**Application for Planning Permission for
Proposed Social Welfare Facility (excluding those involving Residential Care) at
3/F and 7/F, Tower 1, One North, No. 8 Hong Yip Street, Yuen Long, N.T.**
(Application No. A/YL/321)

Response to the Comments from the Transport Department and
the Traffic Report

FINAL TRAFFIC REPORT

Response to the Comments from Electrical and Mechanical Services Department
and the Quantitative Risk Assessment Report

Figure 5.1 Public Transport Services in the Vicinity

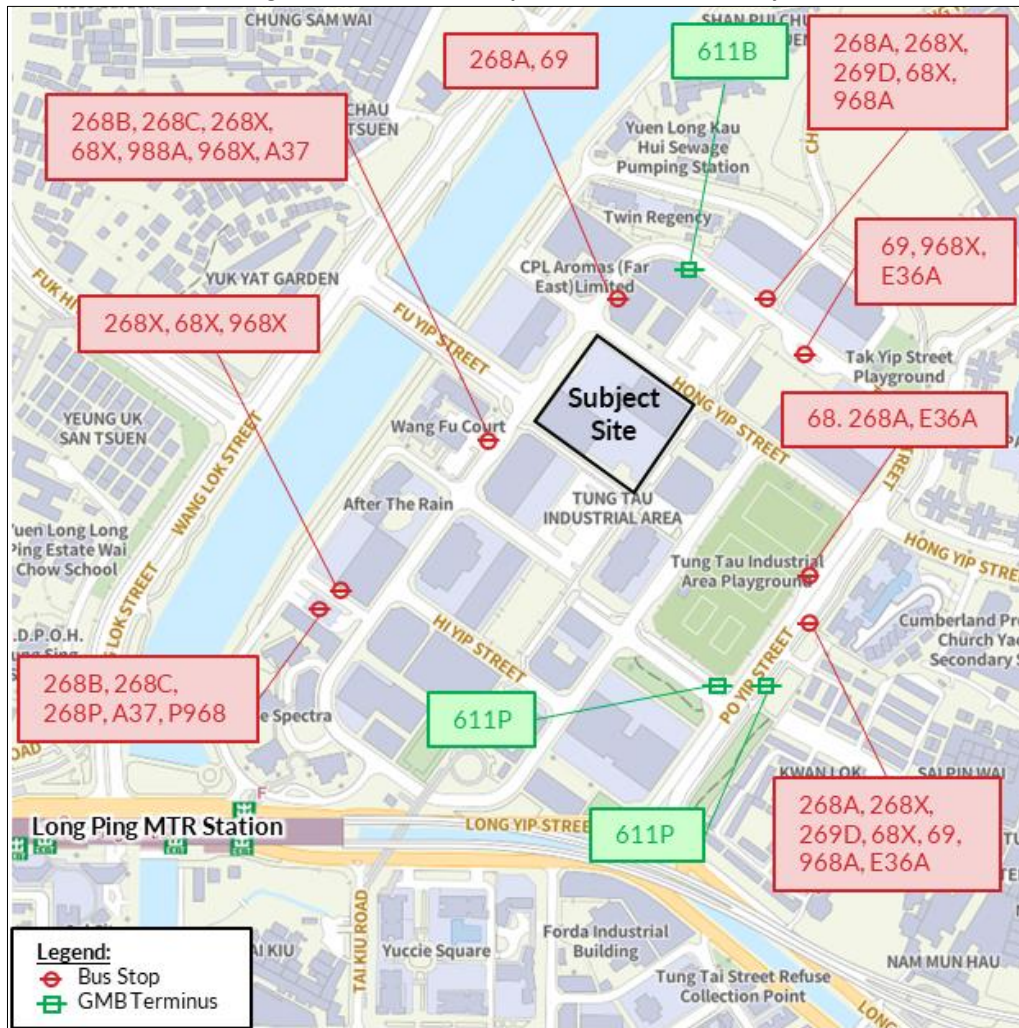
Comments	Responses
<ul style="list-style-type: none"> Considering there will be more children visiting the proposed social welfare facilities, please review the adequacy of nearby pedestrian facilities, especially from public transport facilities to the Premises. Please review the adequacy of nearby public transport facilities. 	<p>As mentioned above, please be advised that less pedestrian traffic will be generated/attracted due to the proposed conversion, hence it is anticipated that there is less demand for nearby pedestrian facilities, i.e. nearby pedestrian facilities are adequate to entertain the anticipated demand.</p> <p>A traffic survey was conducted on a typical weekday in November 2024 to identify the peak hour public transport utilisation at the existing bus and GMB stops near the Subject Site at Wang Yip Street West, Tak Yip Street and Po Yip Street. Please refer to Table 5.2 of traffic report for the observed peak hour public transport utilisation.</p> <p>As illustrated in Table 5.2, all the utilisation rate of existing public transport near the Subject Site are far below 100%, indicating that the demand for existing public transport service is within capacity during AM and PM peak periods for the existing situation and the proposed conversion.</p>

5.1.1. Ten franchised bus routes and two GMB routes are operating in the vicinity of the Subject Site to/from Yuen Long City Centre. Details of these franchised bus and GMB services are listed in **Table 5.1** and **Figure 5.1** below.

5.2.1. A traffic survey was conducted on a typical weekday in November 2024 to identify the peak hour public transport utilization at the existing bus and GMB stops near the Subject Site at Wang Yip Street West, Tak Yip Street and Po Yip Street. The survey results are summarized in **Table 5.2**.

Figure 6 Societal Risk Results

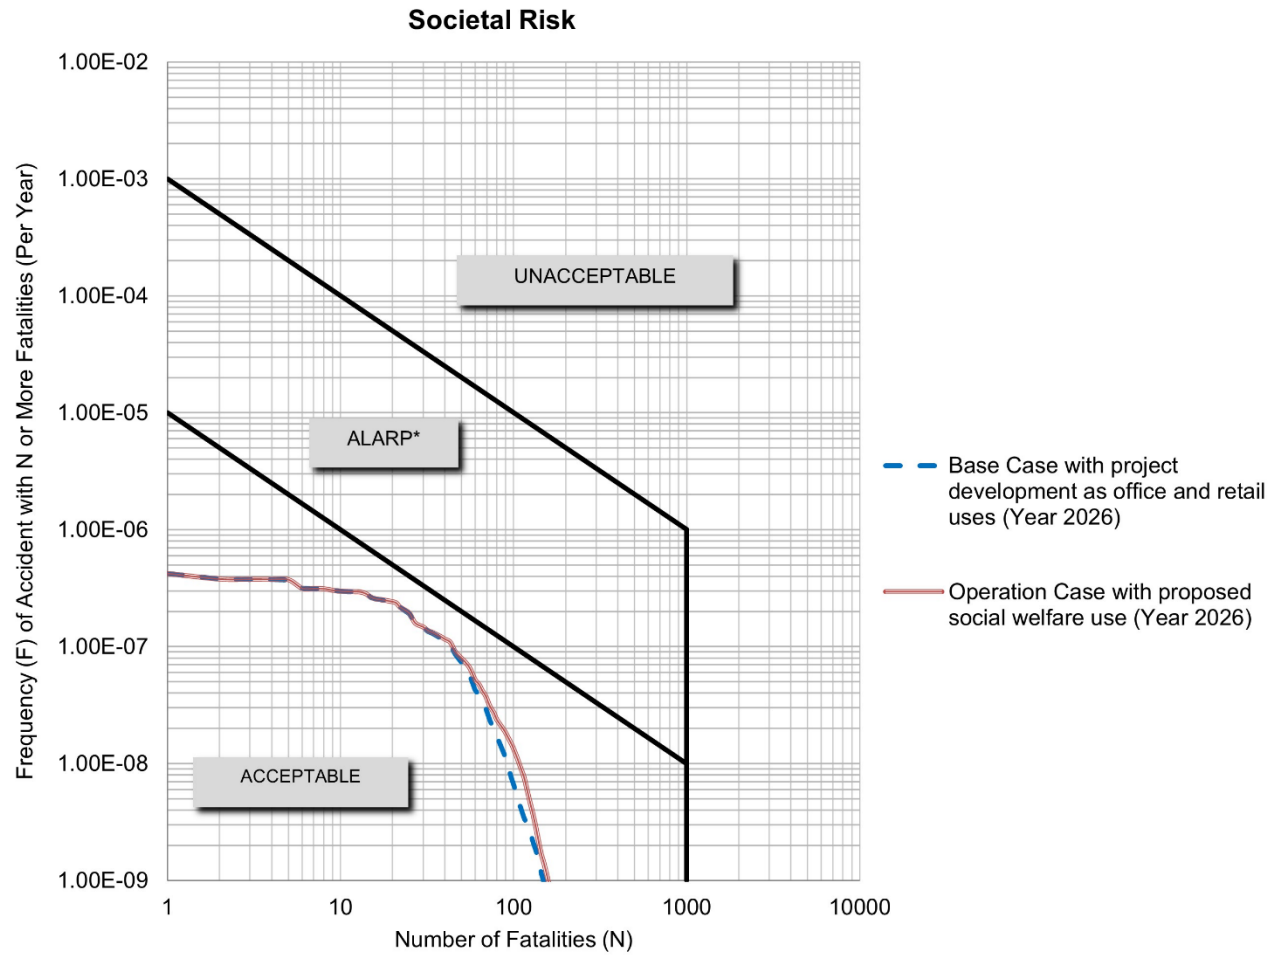
Planning Application A/YL/321		
Comment from EMSD dated 5/11/2024		
	Comment	Response
1.	<p>LGV Safety</p> <p>It is noted that the proposed development would introduce a substantial increase of population to the nearby LPG filling station at Tak Yip Street, Yuen Long. The applicant shall submit a Quantitative Risk Assessment report to ascertain that the risk level posed by the station would be acceptable in accordance with the Government Risk Guideline.</p>	<p>A report is prepared to consolidate findings of the Quantitative Risk Assessment. According to the assessment result, both individual risk and societal risk level posed by the station based on the proposed change of use would be acceptable in accordance with the Government Risk Guideline.</p>

The societal risk results are presented in **Table 17** and **Figure 6**. As recaptured from **Section 1.4.2**, Case 1 - Base Case represents the risk level in year 2025 without the Proposed Social Welfare Development while Case 2 - Operation Case represents the risk level in year 2025 with the operation of the Proposed Social Welfare Development.
